The
University of Oklahoma

**SCHOOL OF AEROSPACE, MECHANICAL
AND NUCLEAR ENGINEERING**

February 14, 1983

We are replying to your letter dated January 18, 1983 and received by us on January 21 as requested. We have attempted to respond to the four items as specifically as possible. We, of course, wish to arrive at full agreement with you as soon as possible.

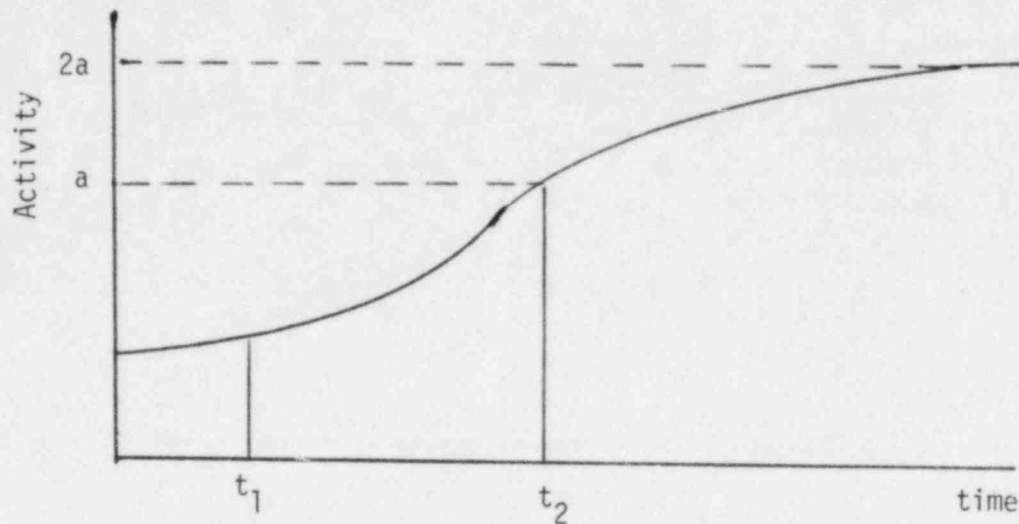
Item 4:

We have now defined the "normal background" as follows: The activity present in the water as a function of operating time is to be measured next week (the procedure must be cleared by the RSC). Referring to the sketch

which shows the activity in water as a function of time, the reactor goes to full power at t_1 . The time t_2

represents the planned operating time (say one hour). Upon reaching full power the operator will set and record the scram setting at value $2a$. If the activity exceeds $2a$ before the time t_2 is reached the reactor is shutdown and the cause investigated.

To ensure the validity of the curve it will be measured again in 6 months.
